Job Name: **Land North of Guildford Road, Bucks Green, Rudgwick**

Subject: **Ecological Technical Note – Response to the LPA Ecology Comments**

Please find the second response to the following with regards to the Horsham District Council request for further information regarding BNG for the planning application ref DC/25/1269 dated 06/11/2025. HDC comments are in *italics* with The Ecology Partnership comments below.

Figure 1: Areas of damaged ground within grassland F1.

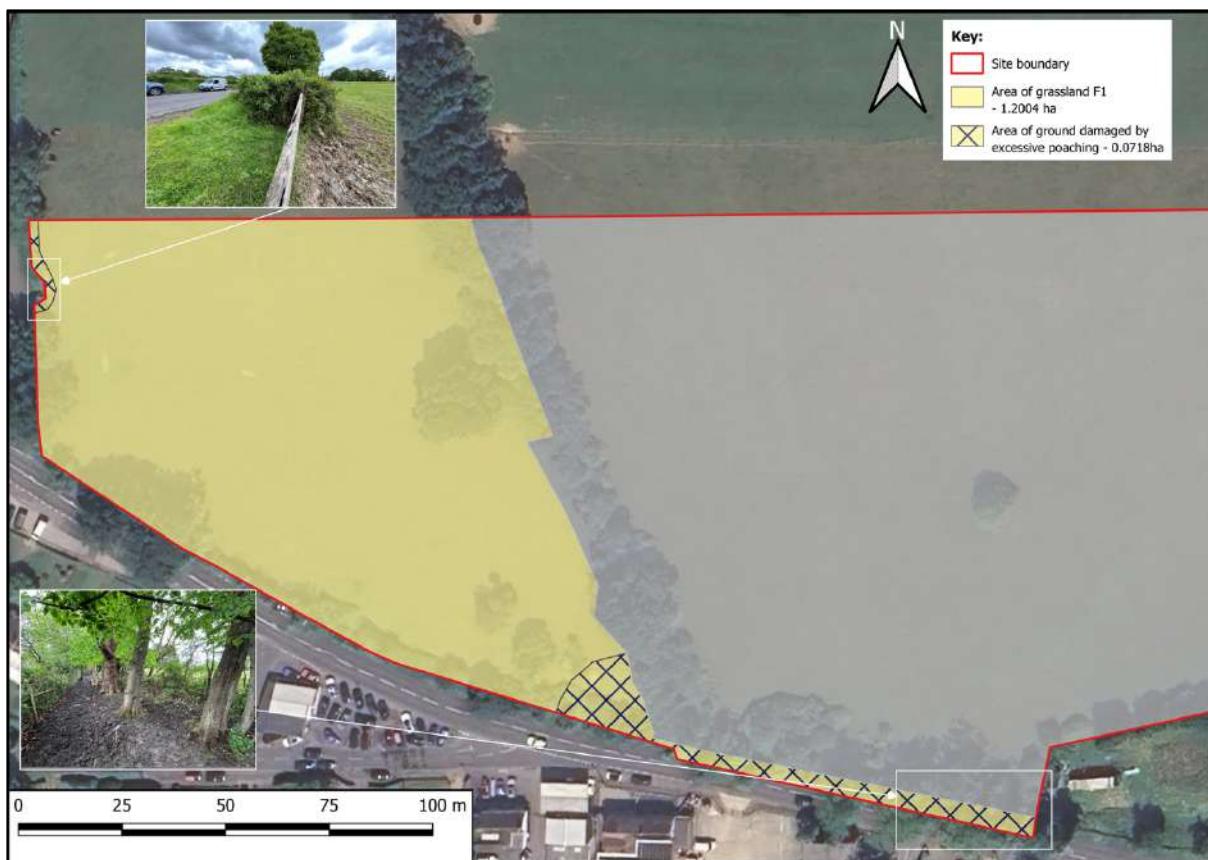
As stated in our previous response, the review of the site conditions was based on review of the technical data and reports we conducted in 2024 to support the application. This is not based on new evidence. When submitted, the condition 'E' of the grassland, which states '*cover of bare ground is between 1% and 10% including localised areas (for example, a concentration of rabbit warrens?)*' was failed as the site was considered to support a reasonable area of poaching by the cows. This was over 10% of the site, albeit this was not specifically detailed in the report. However, as 'E' was failed due to cover of bare ground over 10% than 'D' '*Physical damage is evident in less than 5% of total grassland area. Examples of physical damage include excessive poaching, damage from machinery use or storage, erosion caused by high levels of access, or any other damaging management activities*' must therefore also be failed as over 5% of the grassland has been impacted by damage from poaching.

As such we consider that this is an error that needed to be rectified, especially due to the swing in terms of the net gain, which is wholly reliant on the quality of the grassland. This 'moderate' condition grassland is considered an accurate description of the baseline. The grassland has reached the essential criteria and many of the other criteria, due to the site's use by grazing. However, with cows and the management of the cows, sections of the site, as detailed previously, were bare earth, with areas concentrated around the margins being heavily poached to due the cows. This is shown in Figure 1 below, which was issued in the technical note previously submitted.

It is considered that 'moderate' condition grassland is the most appropriate measure of this field. As such, a net gain is achieved for habitats. However, it is acknowledged that the hedgerow units will have to be purchased off site.

^Hedgerow lining southern boundary on site, as per Figure 4 in BNG Report.

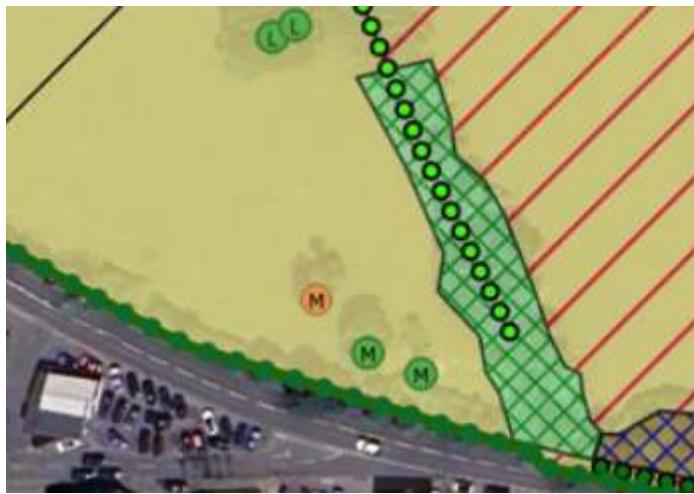
2.1 *As per the Preliminary Drainage Strategy (Appendix A, Paul Basham Associated Ltd, 2025), an attenuation crate is proposed to be installed in the south of the site and appears to be very close to the retained hedgerow. Please can confirmation be sought as to whether impacts on this hedgerow will be avoided.*

The ecologist refers to attenuation basins, however the original comment refers to the attenuation crate – I have copied two extracts below to illustrate this point. Having discussed with the HDC Arboricultural Officer, it is our view that the installation of the attenuation crate is not possible without hedgerow removal and encroaching on tree root barriers adjacent to the existing tree RPAs. Therefore, this will need amending – it is recommended to relocate the attenuation crates or remove the 2-3 plots to the west of the proposed crate to provide sufficient space for installation. A minimum 1.5m distance is required for installing underground crates near hedgerows. Any forecast hedgerow removal will need to be accounted for within the metric.

The Ecology Partnership – this has been addressed in the technical response of the hydrologist.
